Access Compliance Report

Public Rights-of-Way (Curb Ramps)

Intersection ID: 30016	Main Street: KEMPSFORD_DR	Cross Street: LUTON_CT	Location: W
ADA ID: A831236CAAEF	Ramp Type: Perp	Initial Pass/Fail: Fail	Overall Compliance: No
Codes/Mitigation Info/Possible Solution		Field Measurements/Component Compliance	
Severity Score: 8.75

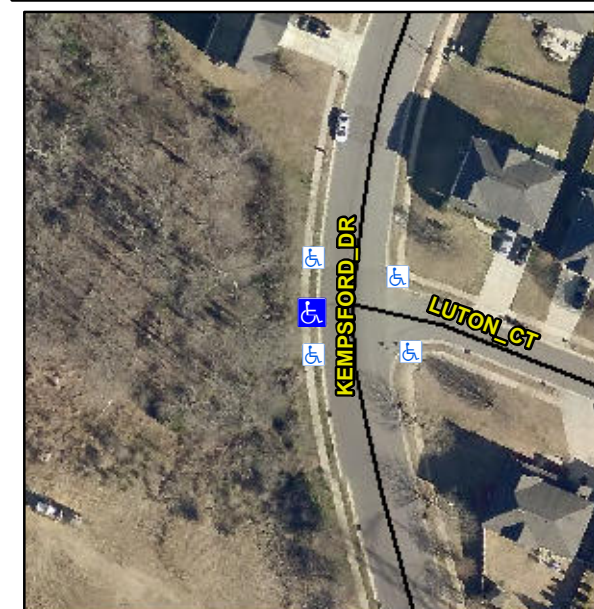
Not Found, R304.5.1

Compliance	Description	Data	Compliance	Description	Data
N/A	Ramp Length (in)	50.0	Yes	Ramp Slope (%)	5.0
No	Ramp Width (in)	40.5	Yes	Ramp XSlope (%)	1.6
N/A	Flare Type LT	N/A	N/A	Flare Type RT	N/A
N/A	Flare Slope LT (%)	N/A	N/A	Flare Slope RT (%)	N/A
N/A	Flare Traversable LT?	N/A	N/A	Flare Traversable RT?	N/A
N/A	Landing Length (in)	N/A	N/A	DWS Provided?	N/A
N/A	Landing Width (in)	N/A	N/A	DWS Contrast?	N/A
N/A	Landing Slope (%)	N/A	N/A	DWS Length (in)	N/A
N/A	Landing X Slope (%)	N/A	N/A	DWS Full Width?	N/A
N/A	Landing Curb? (Y/N)	N/A	N/A	DWS Offset (in)	N/A
N/A	Shared Landing?	N/A			
N/A	Gutter Ponding?	N/A	N/A	Gutter Slope (%)	N/A
N/A	Gutter Lip Ht (in)	N/A	N/A	Gutter X Slope (%)	N/A
N/A	Painted X Walk1?	No	N/A	Painted X Walk2?	N/A
	X Walk 1 Direction	To SE		X Walk 2 Direction	N/A
N/A	X Walk 1 Width (in)	N/A	N/A	X Walk 2 Width (in)	N/A
	X Walk 1 Slope (%)	2.5		X Walk 2 Slope (%)	N/A
	X Walk 1 X Slope (%)	3.2		X Walk 2 X Slope (%)	N/A

Remove & Replace Entire Ramp.
